PROJECT:
 Proposed Building Plans of Group Housing Colony measuring 22.344 Acres (Sector No. 41 of 2010 Dated 07.06.2010) in license-93, Gurugram being developed by Ashiana Housing Ltd. comprising of total of Five (5) phases.

Scale: 1:100
 Drawing Title: TYP FLOOR PLAN (2ND TO 19TH), TERRACE PLAN & AREA CALCULATIONS (ICNIC TOWER - 18)
 Drawing No: A-30

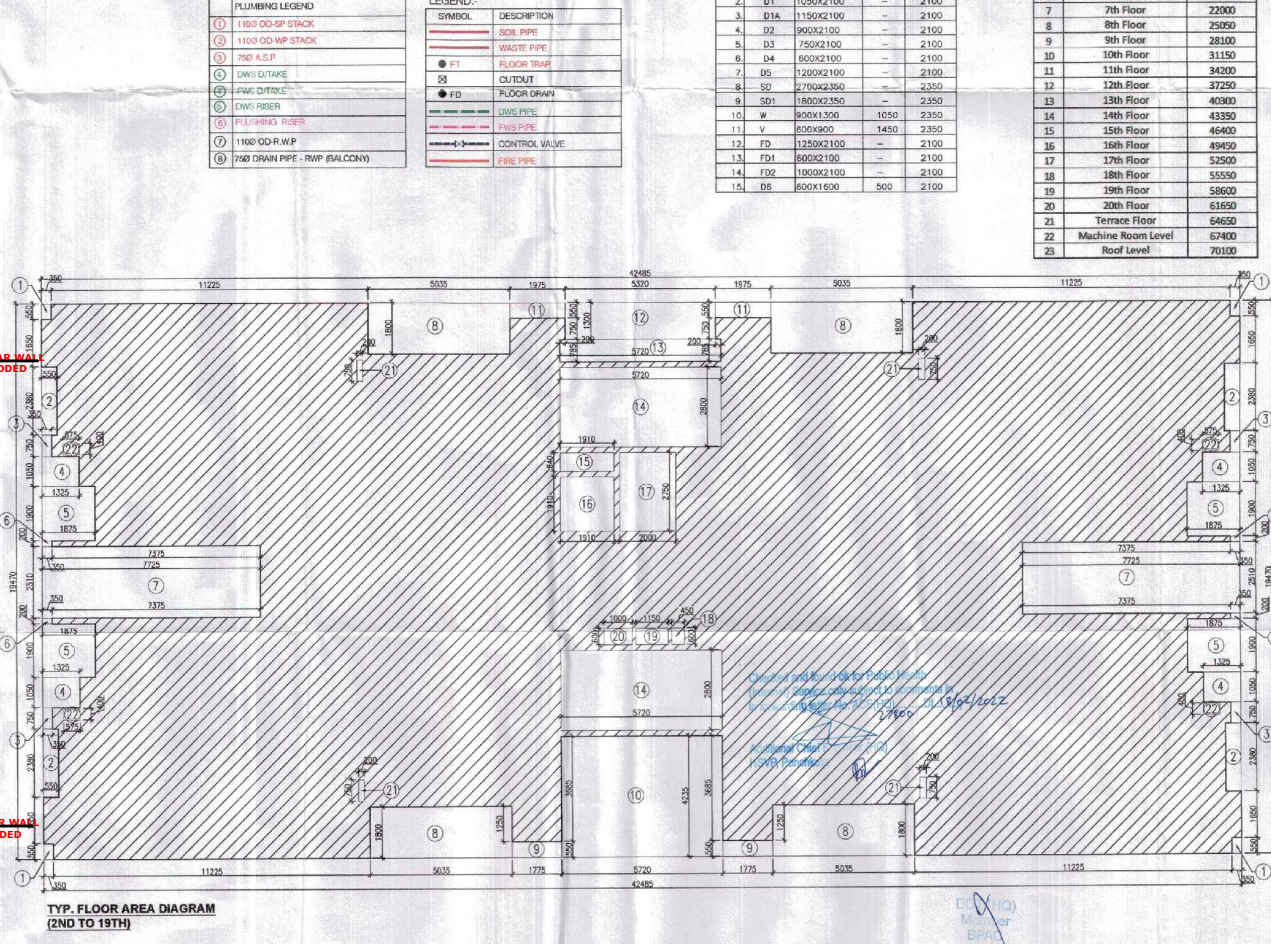
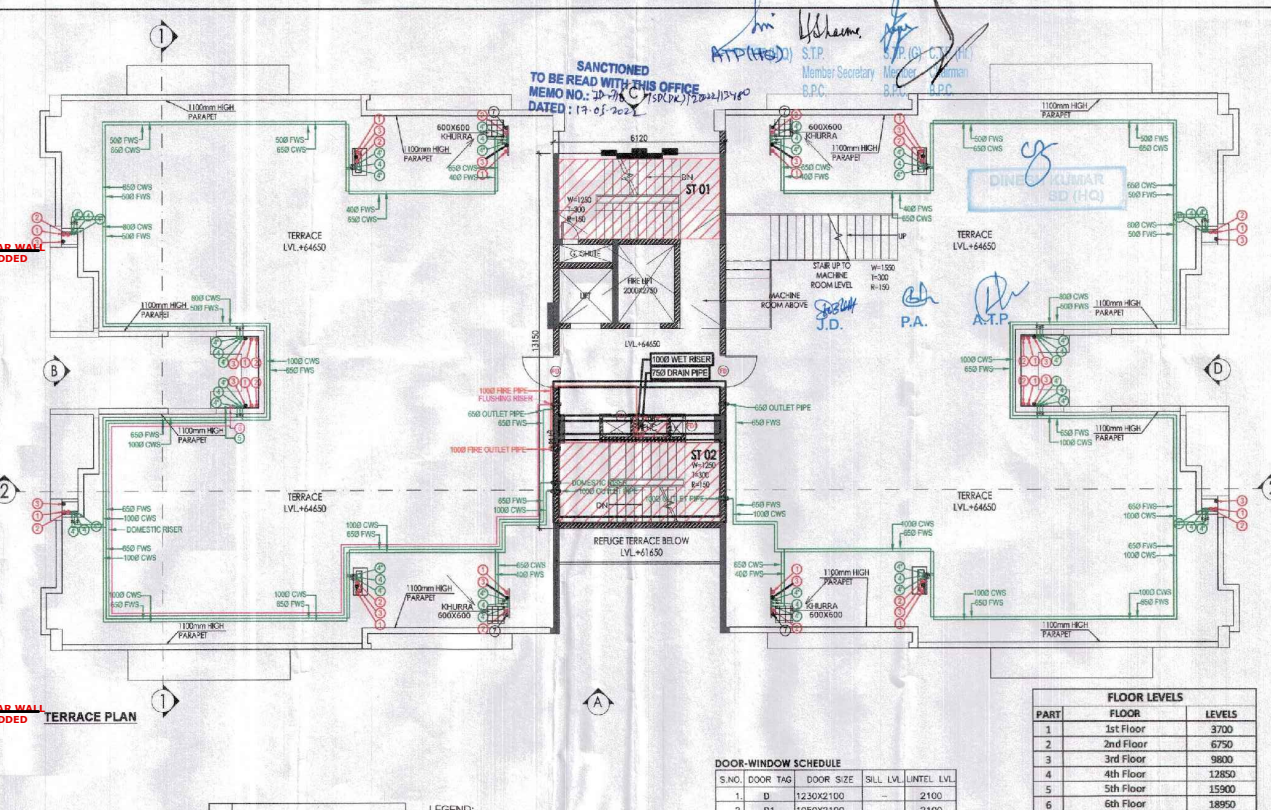
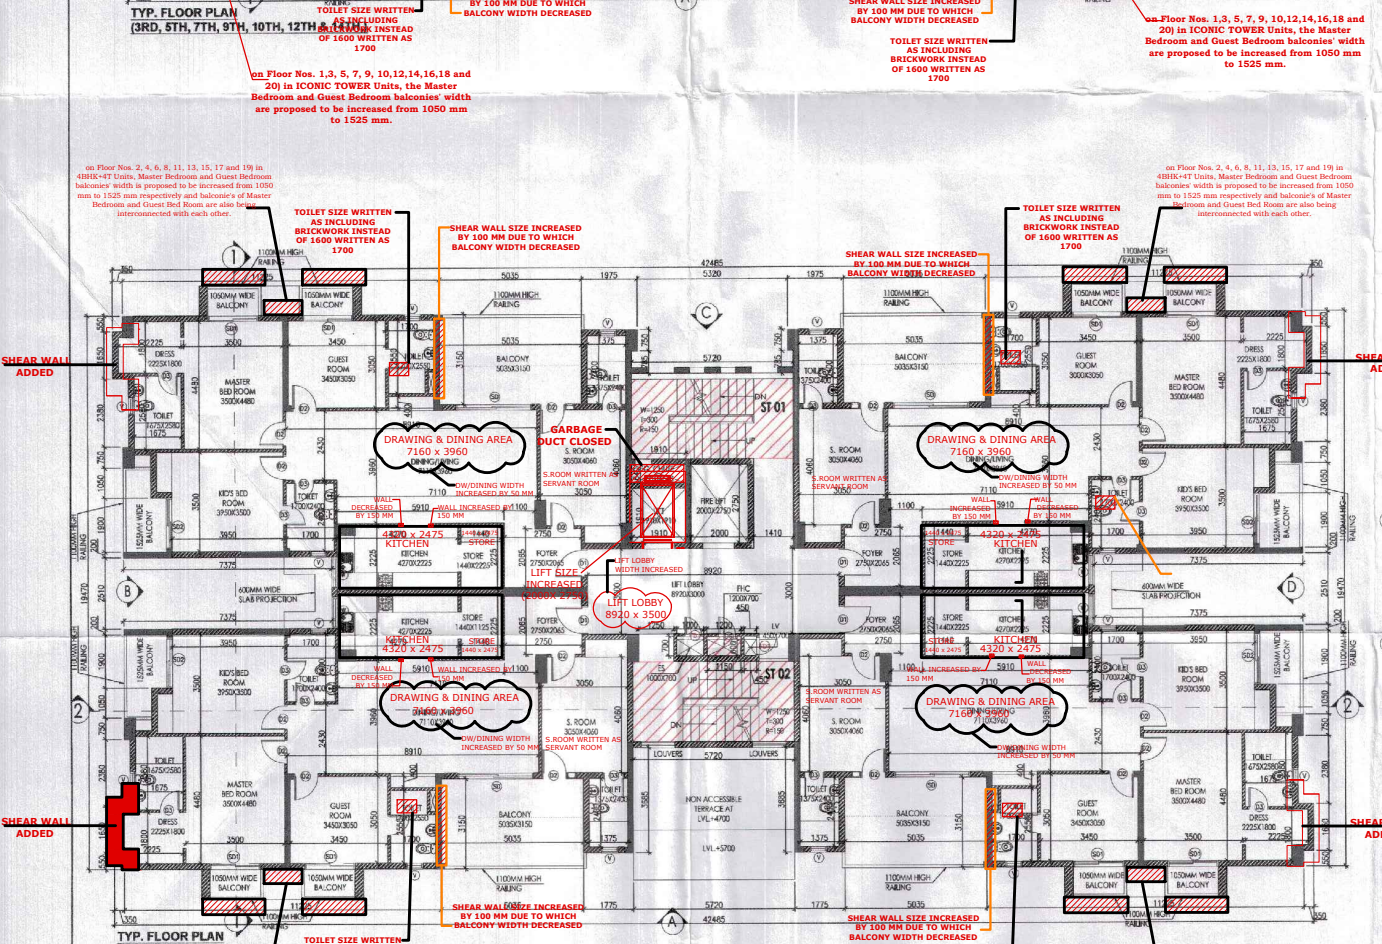
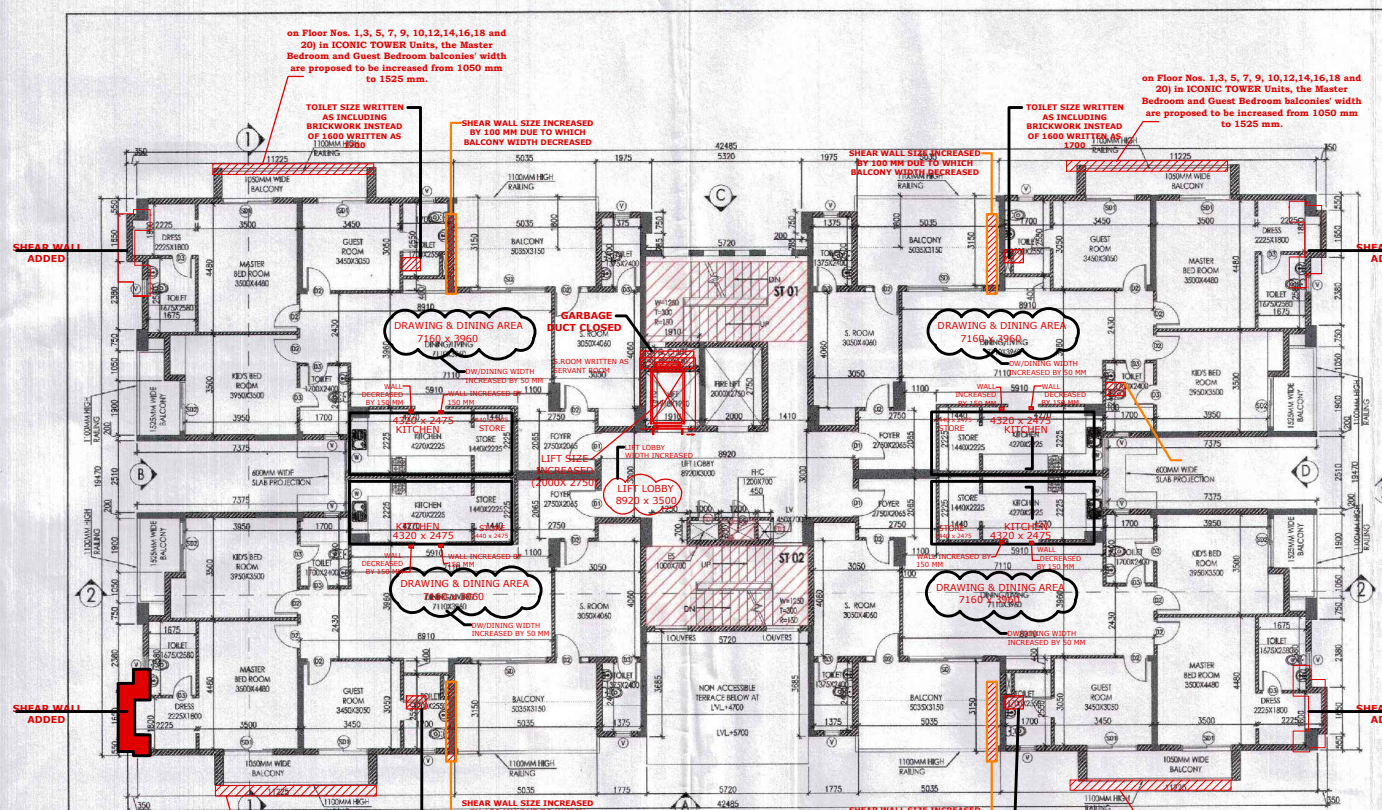
***Length of the Kitchen is proposed to be increased from 4270mm to 4320 mm and width is proposed to be increased from 2225mm to 2325mm.

**Mismatched Between no. of Floor in plans & elevations are corrected Now

NOTE: ELEVATIONS ARE REVISED ACCORDING TO PLANS
